R66 SERVICE BULLETIN SB-10

DATE: 21 November 2013

SUBJECT: Hanger Bearing Assembly

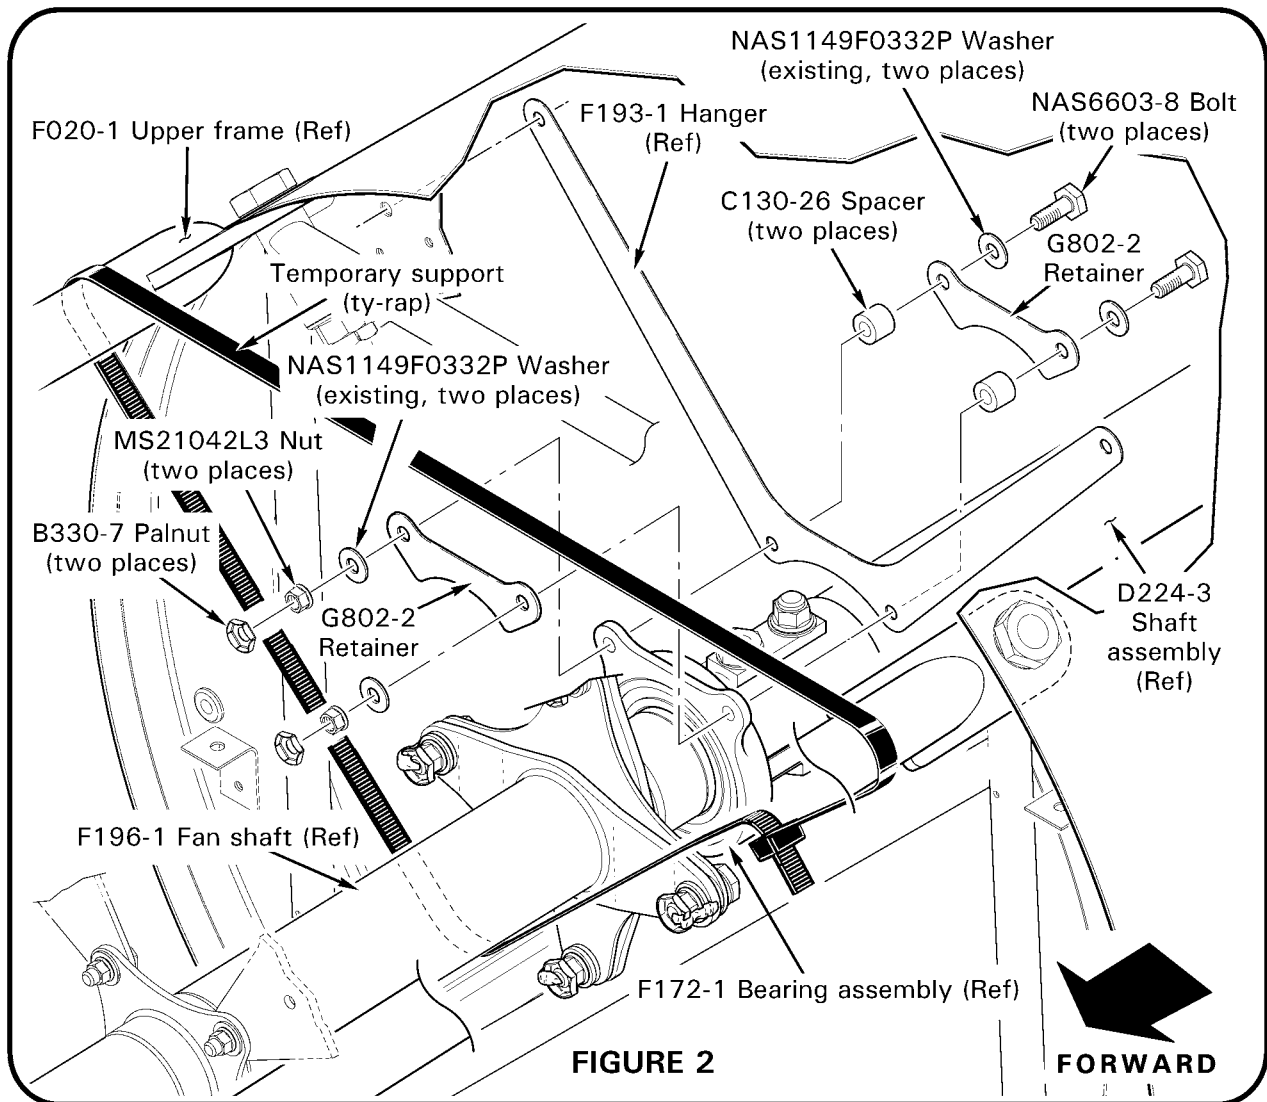
ROTORCRAFT AFFECTED: R66 helicopters S/N 0004 thru 0472. Also spare F172-1 revision B bearing assemblies. F172-1 revision C bearing assemblies are not affected (see Figure 1).

1. Refer to Figure 1. If G802-2 retainers are installed, the requirements of this bulletin have been complied with. Proceed to step 8.
2. Order one KI-222 kit per affected helicopter or per spare F172-1 revision B bearing assembly.

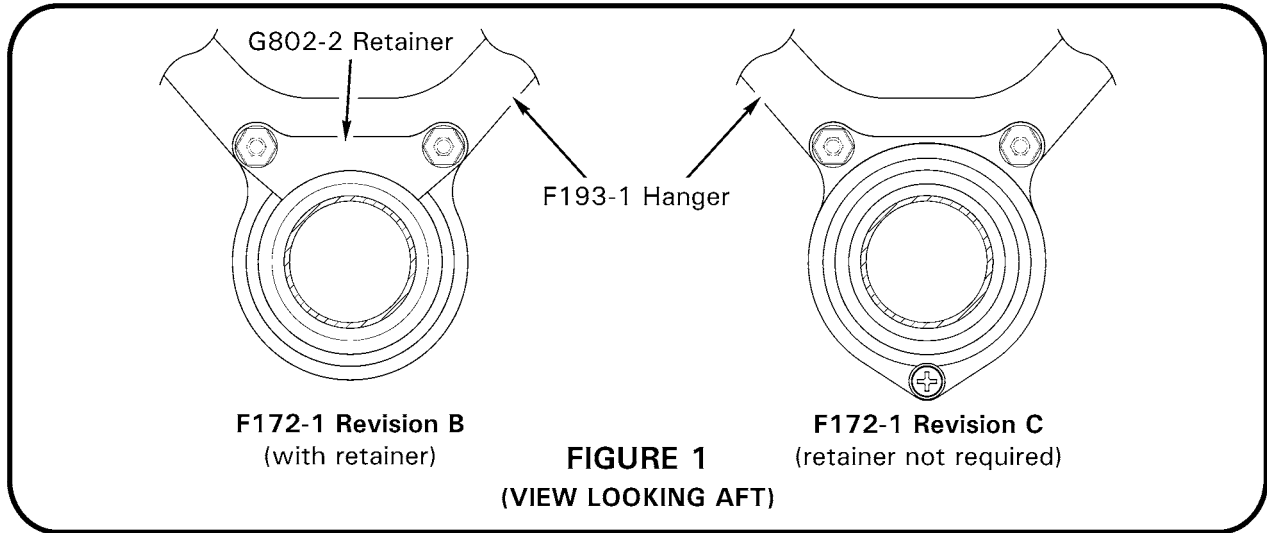
4. Refer to Figure 2. Loop a ty-rap (or similar) around aft end of F196-1 fan shaft and F020-1 upper frame to temporarily support tail rotor driveline.

5. Working with one bolt at a time, remove hardware securing F172-1 bearing assembly to F193-1 hanger and install new retainers, spacers, hardware, and existing washers as shown. Standard torque hardware per MM § 20-32 and torque stripe per Figure 5-1.
